Subject: Duke Energy Corporation
Catawba Nuclear Station, Unit 1
Docket Number 50-413
Request for Relief Number 05-CN-001
Reply to NRC Request for Additional Information

REPLY TO NRC REQUEST FOR ADDITIONAL INFORMATION

Catawba Nuclear Station, Unit 1 Relief Request 05-CN-001 -
Request for Additional Information

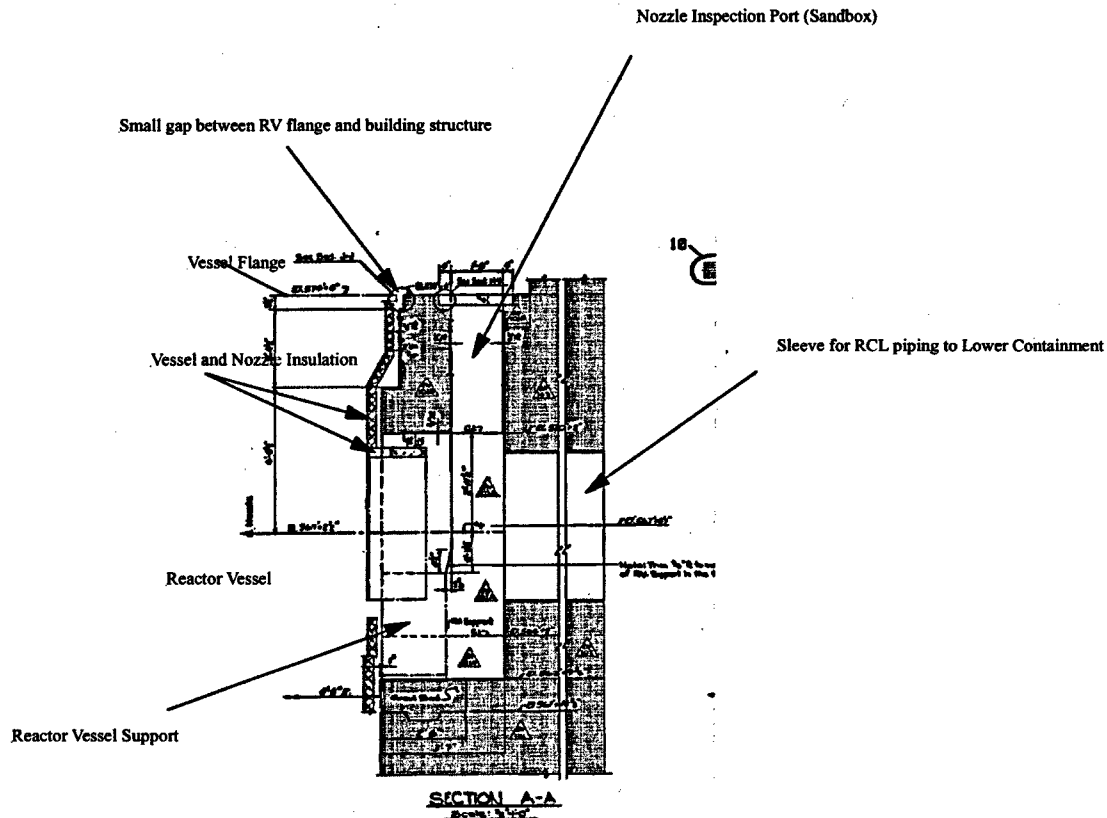
2.2.3 The submittal adequately explains the interferences caused by the RPV insulation and biological shield wall, and states that an area approximately 71-inches long by 36-inches high could not be visual VT-3 examined on the vessel side of each of the subject supports, even with remote camera systems or mirrors. Please report the percentage of the ASME Code examination boundary actually obtained for each of these supports. In addition, discuss whether access to the vessel side of these supports is available by remote means after the refueling canal has been drained and the refueling cavity/RPV seal deflated or removed.

In light of recent events, the potential for boric acid to cause severe wastage on carbon steel components is of significant concern to the staff. Several generic letters and bulletins have been issued to address the

potential for degradation due to boric acid in contact with carbon steel (Generic Letter 88-05, Bulletin 2003-02, etc.). Because the vessel side of the subject supports is not currently being visually examined, provide a basis to ensure that wastage is not on-going in these areas. Additionally, discuss whether the subject RPV supports should be examined more frequently than once every 10 years, as is required by ASME Code, given these concerns.

Approximately 50% of the support was examined. A pole camera was inserted in each of the four nozzle inspection ports (sandboxes) from above. The entire support was inspected from the outboard side. However, there is no access to the inboard side of the support.

There is no direct access to the vessel side of these supports with the refueling cavity seal removed. The drawing below shows the general configuration and the very limited space (approximately 2") between the reactor vessel and the concrete building structure. The vessel insulation in the gap between the reactor vessel and the building structure limits the access for a borescope or other optical device through the refueling cavity seal gap. Although a small gap is present, there remain two horizontal offsets and the nozzle insulation that preclude an effective visual inspection of this side of the support. The vertical distance (8 to 10 feet below the flange) combined with the horizontal offsets and existing vessel and nozzle insulation prohibit an effective remote visual examination.

The reactor vessel supports are located on four of the eight reactor vessel nozzles. The only potential welds (see note below) that represent a leakage source that could degrade the support from the inboard vessel side are the vessel nozzle to shell welds and the circumferential vessel flange to shell weld. These low alloy steel welds are volumetrically examined every ASME XI inspection interval. Based on these recent successful inspections with no reportable indications and PWR operating experience, a leak at these locations is extremely unlikely. Leakage during refueling activities through the cavity seal is possible but based on corrosion rates and the condition of the support on the sandbox side subjected to similar leakage, there is no concern with any degradation of the structural capacity of the support.
